LAND REDEVELOPMENT COMMITTEE

Date: 7 September 2026
Item 2.1: Lot 6 Victoria Street, Midland – Four- and Five-Storey Multiple Dwelling (Social and Affordable Housing) Development
Submitted by: Conor Ward

Project Area: METRONET EAST – Midland Project Area
Location: Lot 6 Victoria Street, Midland
Owner: Minister for Western Australian Government Railways
Applicant: EMCO on behalf of DevelopmentWA
Proposal: Four- and Five-Storey Multiple Dwelling (Social and Affordable Housing) Development

LANDSCAPE CONCEPT PLAN

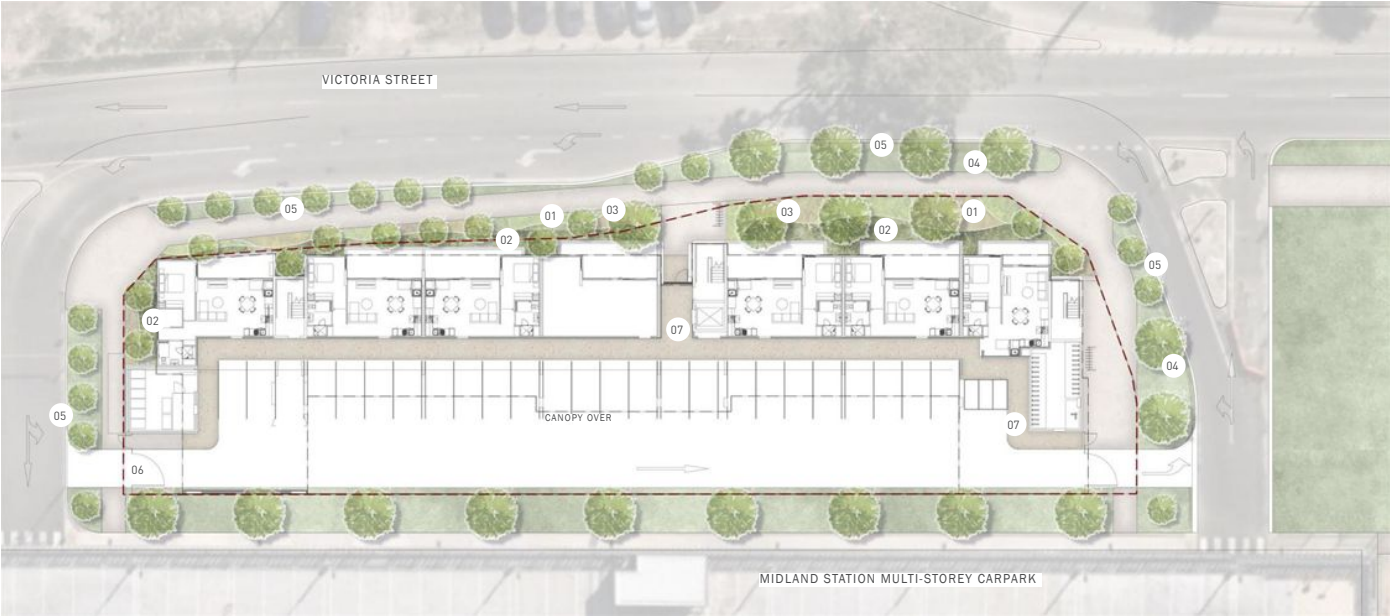
- **Landscape quality:** The success of the landscape response will depend on species selection, consideration of Midland's landscape context, and the careful alignment of trees to establish a consistent streetscape rhythm. The design of the southern fence including height, location and integration with the public open space are noted, and opportunities for landscape to play a stronger role in screening and security should be further explored.

- Review of the landscape design and species palette to better respond to the Midland context, including opportunities to incorporate contextually appropriate native species in place of, or alongside, exotic species.
- The green buffer to Victoria Street is positive and generous in scale. Further consideration should be given to increasing the use of medium and large canopy trees to strengthen shade, visual relief and rhythm of streetscape planting.
- The positioning and spacing of trees should be carefully considered to provide a consistent landscape rhythm and built form particularly along Victoria Street.
- Explore opportunities for the provision of climbers or other landscape treatments along the southern fence line adjoining the bus interchange to soften the interface and improve visual amenity.

4. A revised landscape plan detailing both soft and hard landscaping elements and ongoing maintenance and management requirements is to be provided at planning condition clearance (working drawings) stage and implemented thereafter, to the satisfaction of DevelopmentWA, in consultation with the City of Swan. (Refer to Advice Note e)
